RESPONSE TO REQUEST FOR ADDITIONAL INFORMATION

APR1400 Design Certification

Docket No. 52-046

RAI No.: 199-8223
SRP Section: 03.08.01 – Concrete Containment
Application Section: 03.08.01
Date of RAI Issue: 09/08/2015

Figure 1 Radial or Vertical Displacements of RCB under Internal Pressure, Nonlinear Analysis Results for UPC Evaluation (Dot line: APR1400, Solid line: SKN34)

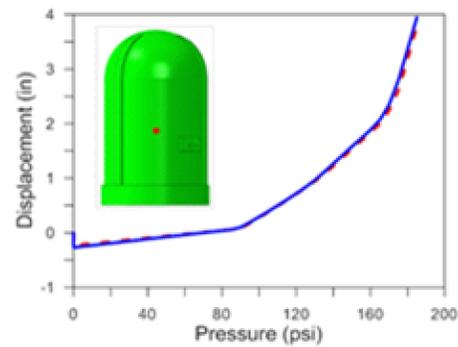
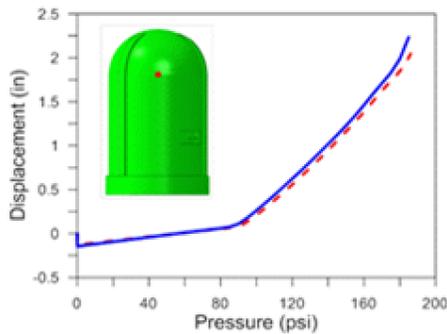
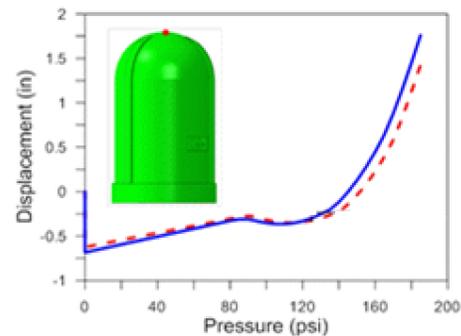
- d. From the information provided in Section 3.8.1.7.2 of the DCD, it is not clear to the staff whether all applicable positions of Regulator Guides (RG) 1.35 and 1.35.1 are performed for the inservice inspection of the tendon systems or whether there are any exceptions. From the information provided in Section 3.8.1.7.2 of the DCD, it is not clear to the staff whether all applicable positions of Regulator Guides (RG) 1.35 and 1.35.1 are performed for the inservice inspection of the tendon systems or whether there are any exceptions. The applicant is requested to provide this information in the DCD.

In addition, there is a comparison between APR1400 and Shin-Kori Units 3&4 under ultimate pressure. The static behavior and ultimate pressure capacity (UPC) of the APR1400 RCB under internal pressure is almost the same as those of Shin-Kori Units 3&4. The increased wall thickness affects the ultimate pressure capacity of the RCB, but the behavior of both NPP RCBs is almost the same, as shown in Figure 1.

The 6 inch linear increase in wall thickness may result in different stresses, strains and displacement from Shin-Kori Units 3&4. However, inherent behavioral characteristics are not changed due to the structure's shape and composition being the same as Shin-Kori Units 3 & 4.

As a reference, Regulatory Guide (RG) 1.18, which was withdrawn in 1981, provided the definition of prototype RCB. At present, no regulatory document clearly defines classification criteria to be used to determine if a containment is prototype. Based on RG 1.81, Revision 1 (1972), Appendix A, the following discussion is prepared to demonstrate that the APR1400 RCB is not a prototype. Review items in RG 1.81 demonstrate that changes made in the APR1400 containment should not be considered reasons to classify the RCB as a prototype.

Figure 1 Containment Pressure and Temperature Profile after Design Basis Accident

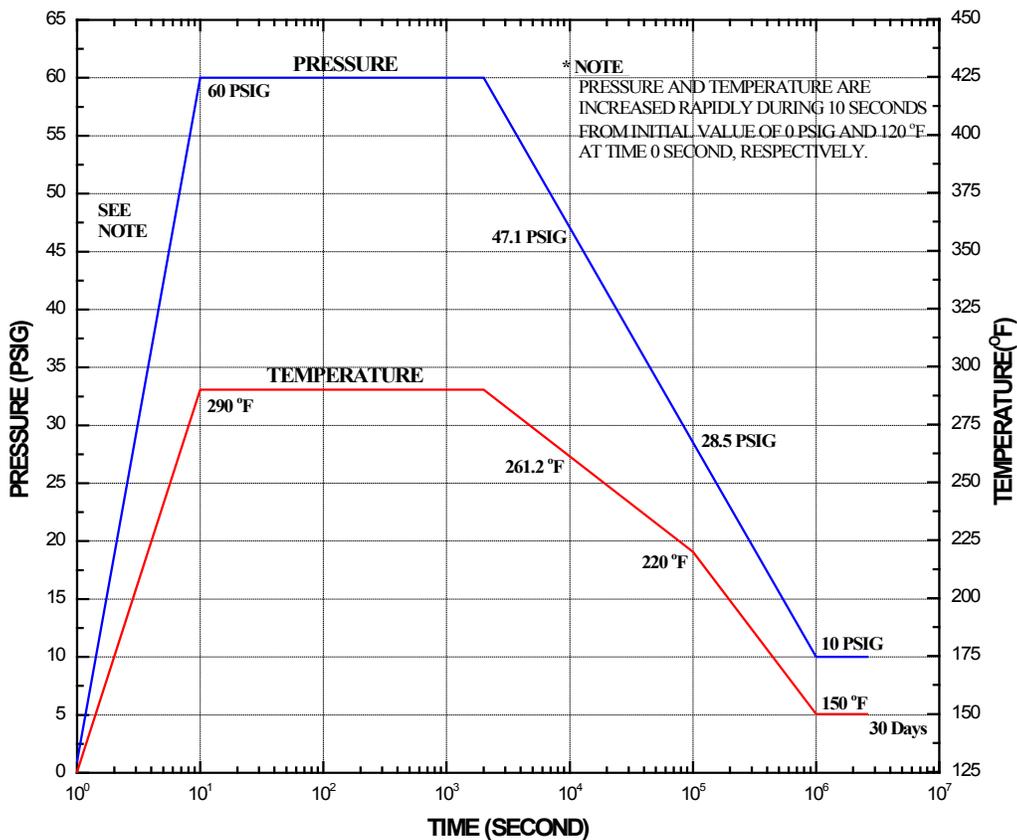
DCD Tier 2, Section 3.8.1.4.5.2, "Thermal Stress Analysis," discusses the thermal analysis of the containment and Section 3.8A.1.4.1.3.2 discusses the effects of temperature variations during normal operating and accident conditions. However, these sections do not provide the design temperatures used for normal and accident conditions. Per Appendix A to 10 CFR Part 50, GDC 1, 2, 4, 16 and 50; and SRP 3.8.1, the applicant is requested to include in the DCD the ambient temperatures inside and outside containment considered for design during normal and accident conditions. In addition, for variation of temperature through the containment thickness, provide the results of the thermal analysis showing the gradient for the various cases (normal loading and accident loading over time), and identify which ones have been used in the design of the containment.

The temperature transients result in a nonlinear temperature distribution within the concrete; results presented in this response are taken from the transient heat transfer analysis. Figure 1 shows typical temperature profiles adjacent to the liner plate after a design basis accident, and Figure 2 shows the typical temperature profiles of the containment wall, which is exposed to the atmosphere.
